Application No.: 10/690,463

Docket No.: JCLA12280

REMARKS

FIG. 2

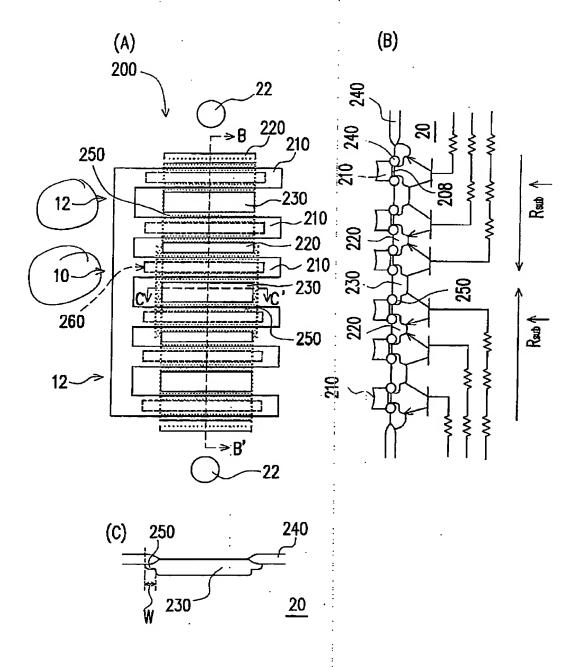
In addition, the drawings were objected under 37 CFR 1.83(a) because the drawings do

not show every feature of the invention specified in the claims. In response thereto, applicant has

amended claims 1, 2, 4, 9, and has also added the reference number 10, 12 in the Fig. 2 (A) and paragraph [0018]. Every feature in the amended Claims 1, 2, 4, 9 and 10 is shown in the

drawings and no new matter is entered.
